SUBJECT: **Scott's Seafood Restaurant, Jack London Square, Oakland, Alameda County**
(For Board consideration on April 6, 2015, Second Pre-Application Review)

**Scott's Restaurant
Jack London Square
Public Pavilion Modifications and
Public Access Enhancements**

SUBJECT: Approved Minutes of April 6 2015 BCDC Design Review Board Meeting

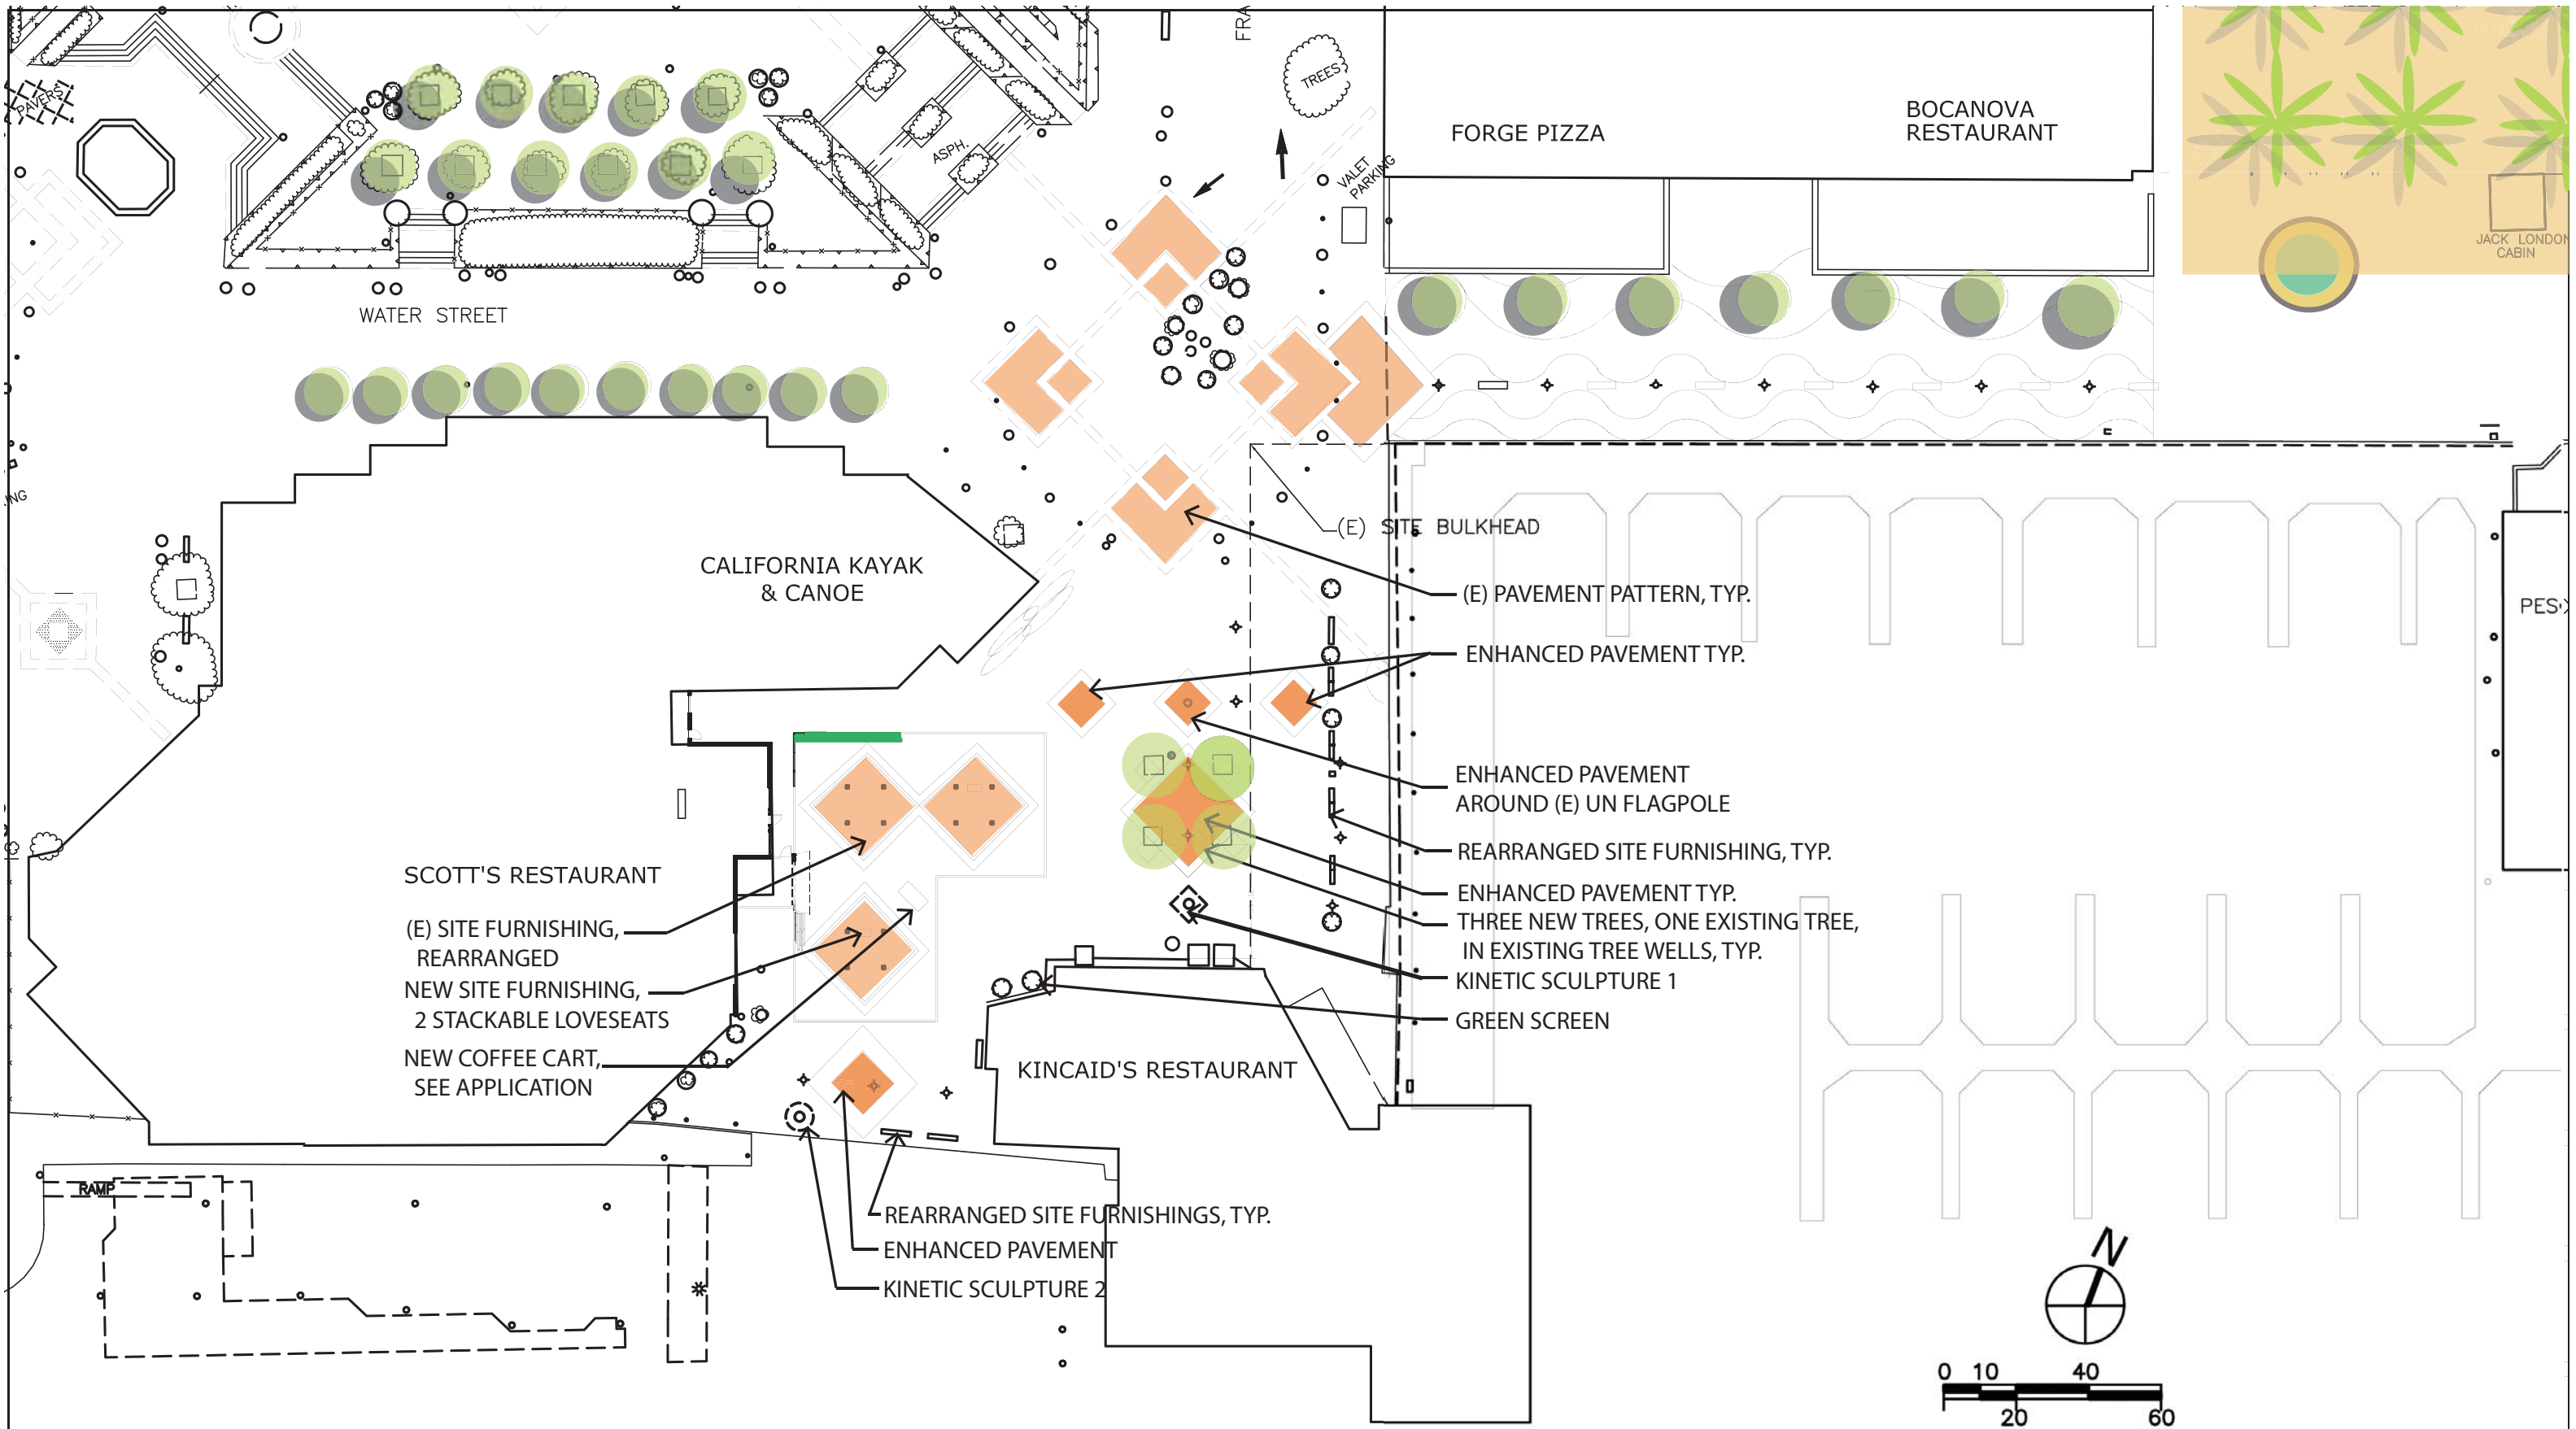
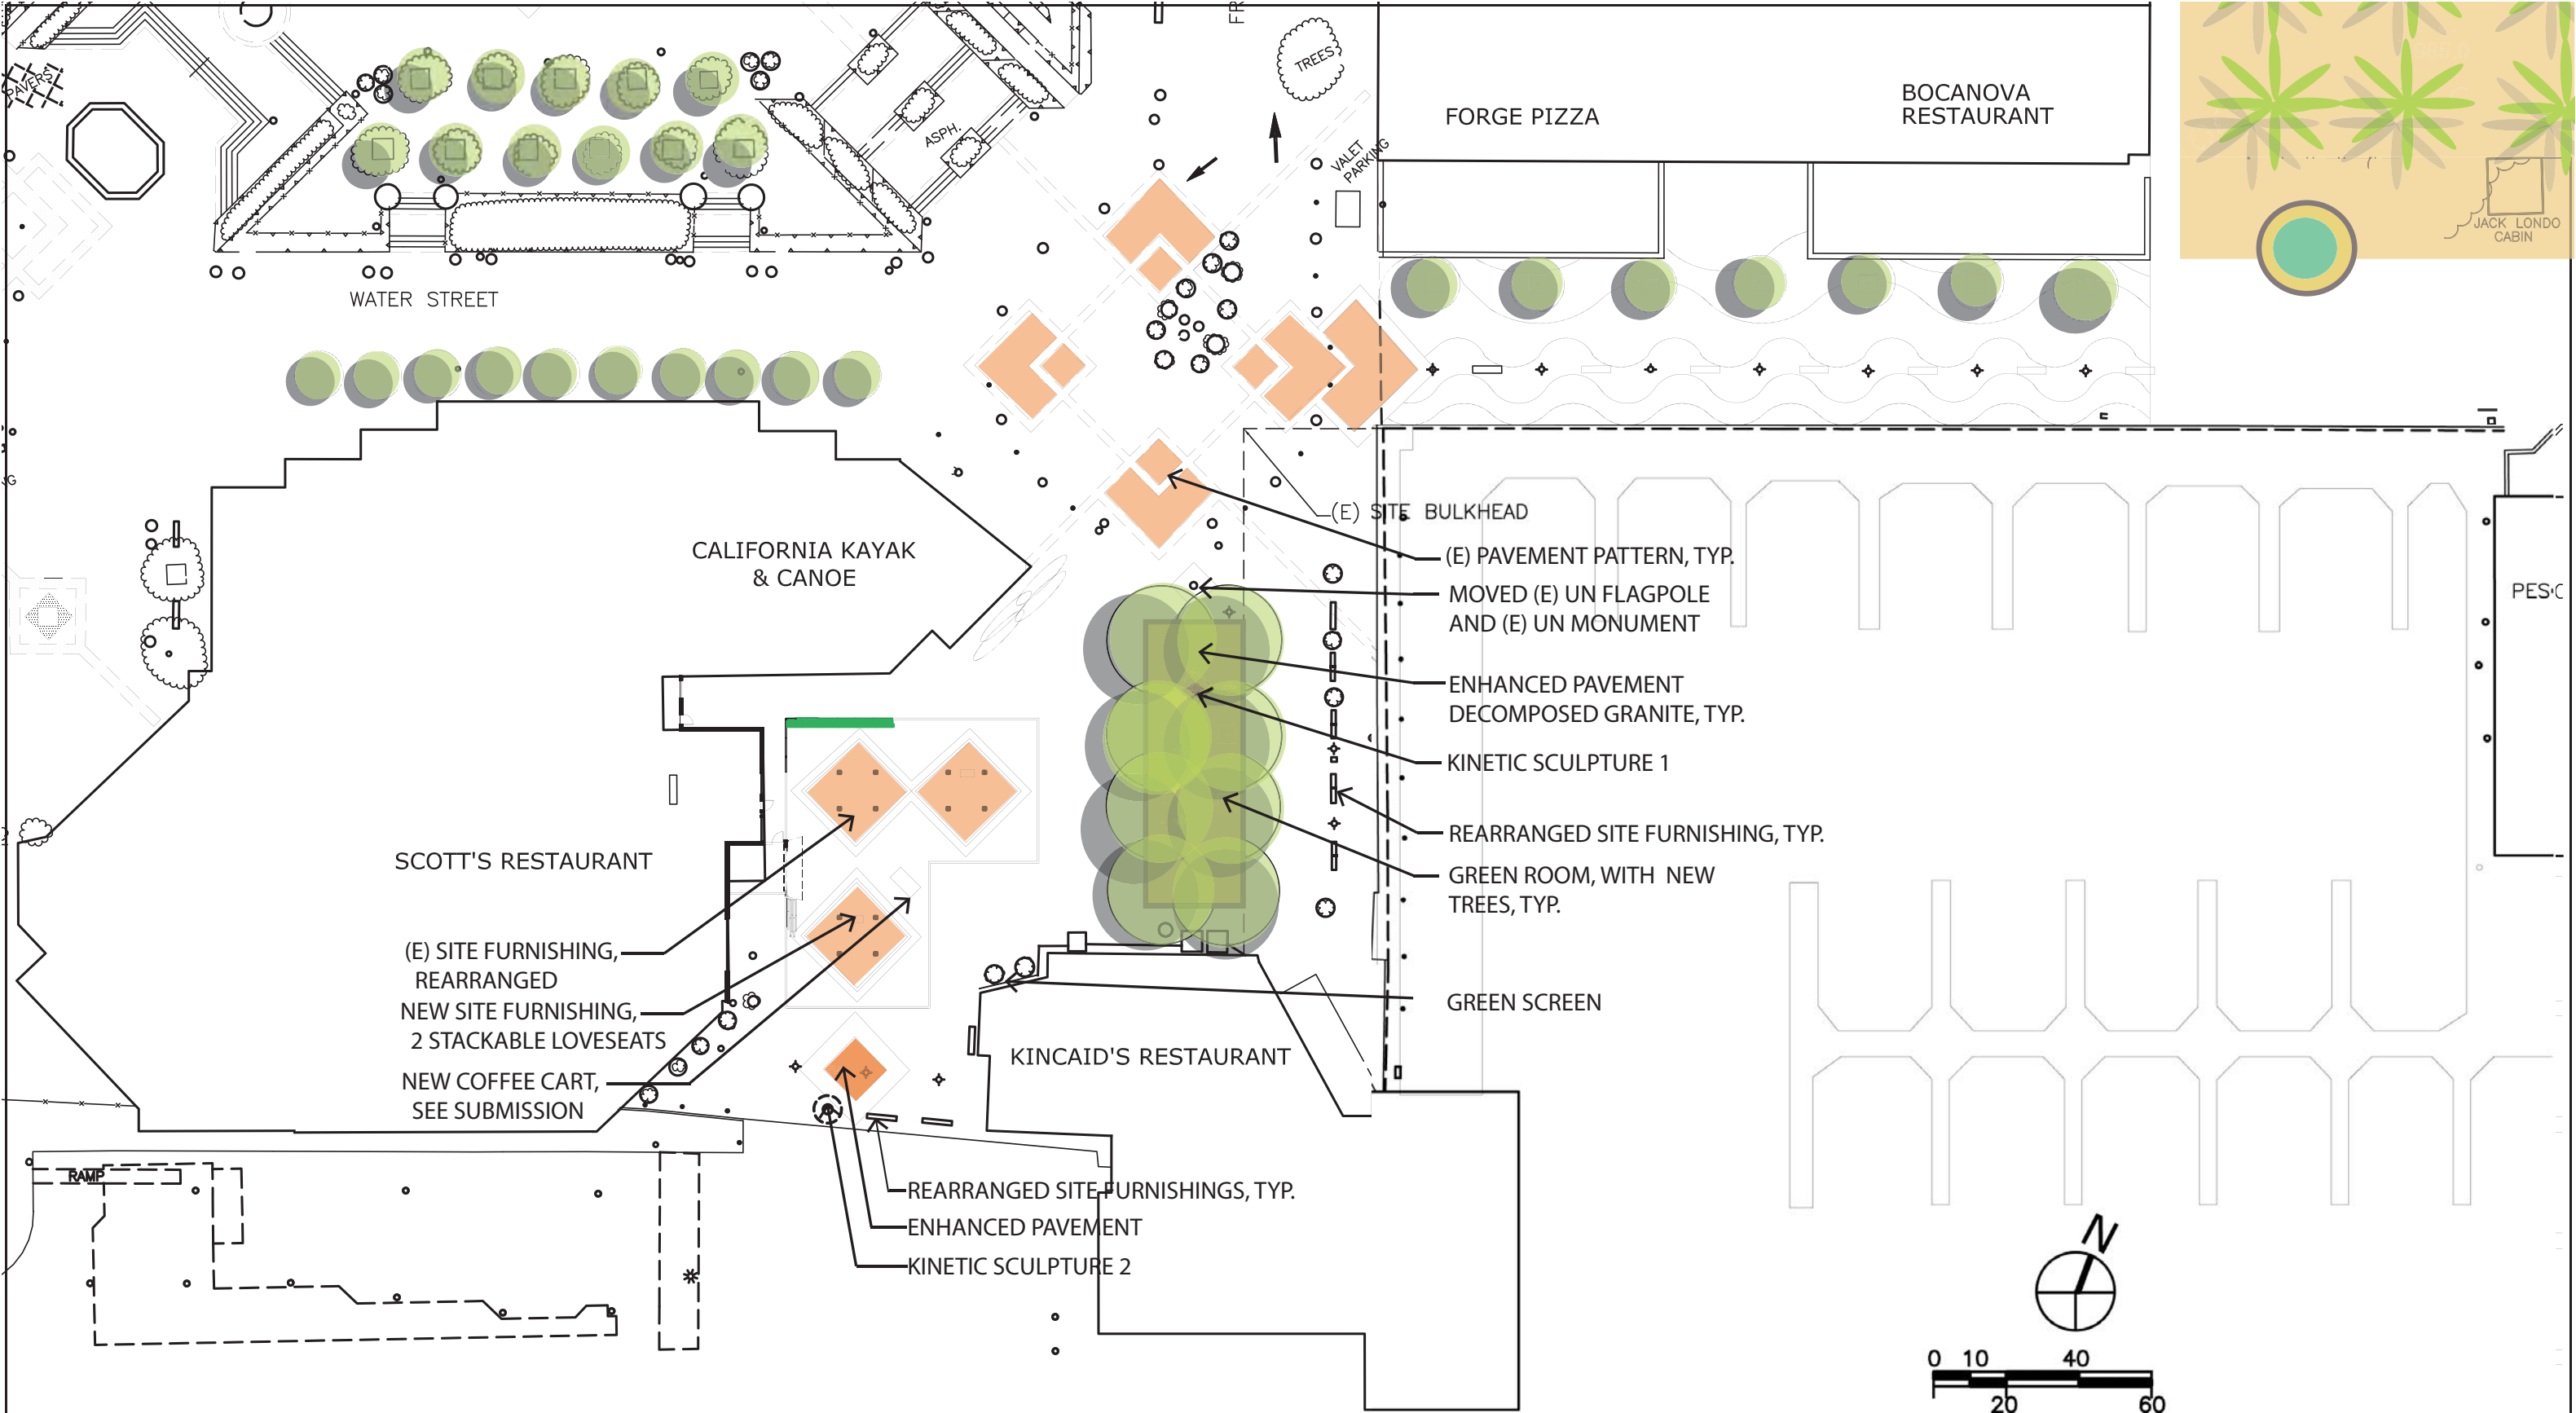
Mr. Kriken commented that the perspective sketch of the proposed plaza improvements revealed that “visually everything was competing for attention.” He noted that the proposed trees block the sky and do not draw attention to the water but rather block views to it. The space would be more powerful if left open to the sky. He further noted that the proposed sculptures appear “antithetical” to the maritime environment and distract from the view towards the water. He suggested placing a “beautiful boat” in this plaza area instead. The current proposal reminds him of a shopping center and it would be better to have a design that clearly reminds one of where they are adjacent to the shoreline. He noted that currently, “the only thing that reminds you of where you are, are the kayaks.”

Ms. McCann commented that the enhanced paving may not accomplish very much and, if paving enhancements were made, she would prefer the wave pattern as opposed to the diamond shapes. She agreed with Mr. Kriken that the maritime character of the area should be emphasized and any proposed changes should be measured by their maritime qualities. She stated that something that the public is really strongly attracted to should be placed in the open plaza area. There could be an exhibition space with artifacts from a maritime museum rotating periodically for display. She further recommended that the plaza be cleared of “clutter” and new seating should be very simple such as a linear seatwall aligning with the eastern shoreline.

(2) **Plaza and Shoreline Edge Should Be Open and Simple in Design.** The view corridor to the Bay should be emphasized by minimizing vertical elements and only using vertical elements if they can help “frame” the view corridor and create a “procession” towards the water. The proposed trees and sculptures block the view to the water. Many Board

members discouraged using any trees since they would block views to the water. There should be simplicity in all design choices. For example, simple concrete seatwalls could be used rather than benches. Paving enhancements may not help unless they are tied to an overall framework. The proposed planters are obstructive and should not be included.

g. **Project Proponent Response.** Mr. Hanson thanked the Board for their comments and made a few clarifications. The kinetic sculptures were proposed as an attempt to draw people to the shoreline. The previous wave pattern paving is not perceptible at the ground level and so alternative paving design enhancements were envisioned for this area around the pavilion. It is possible to use palm trees in the Franklin Street plaza area, as had been previously proposed in this area under prior designs by others and as are currently installed at the foot of Broadway, if these were desired and would better preserve views to the Bay.
